MODEL 240 S/140 S

IGNITION SYSTEM – See service bulletin X 85.102-26

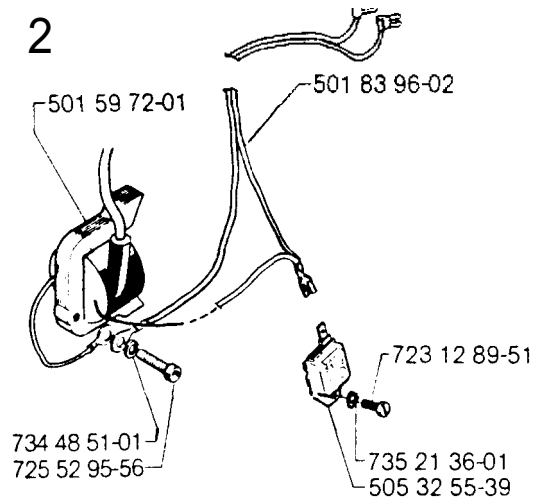
1. Ignition coil Kit (2-legged) 501 69 07-02 is excluded. The ignition coil is no longer in production.
2. Remaining parts in the kit are the same as for the model 44, according to the illustration below.
Compare with service bulletin 85.102 and the assembly instruction.
3. Ignition coil for the model 44 (3-legged) replaces the previous (2-legged) by cutting the upper leg off. See the illustration below.
